Members of Mahomet Aquifer Consortium asked me to send you the comments concerning the Clinton Landfill application that I prepared for them. I serve as a technical advisor to the consortium. There are some critical inconsistencies in the water table elevation data used by USEPA to state that the PCB landfill will meet the necessary regulations. If the correct data is used, the permit would not be acceptable according to the regulations as stated in the permit.

All underlined items are directly from the USEPA draft permit approving the landfill.

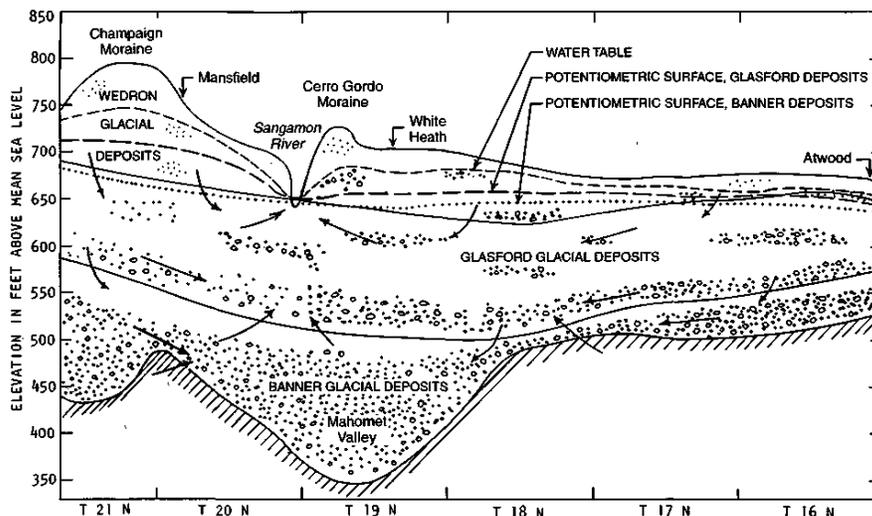
The true water table (the elevation of a free-water surface at which the pressure is equal to and responsive to atmospheric pressure) in across most of Illinois where there are glacial deposits is generally less than 10 feet from the surface. This is why there are extensive networks of drainage tiles in the farm fields and why our cemeteries are on hillsides or in sandy deposits. Information on water table elevations and fluctuations can be found on the ISWS WARM network webpage. (<http://www.isws.illinois.edu/warm/sgwdata/wells.aspx>).

The requirement that the bottom of a landfill accepting PCB wastes be 50 feet above the historic water table probably eliminates more than 90% of the land in Illinois from having one of these landfills. A representation of the water table typical of Piatt and DeWitt Counties is show in on Figure 9 in Anliker and Sanderson (1995):
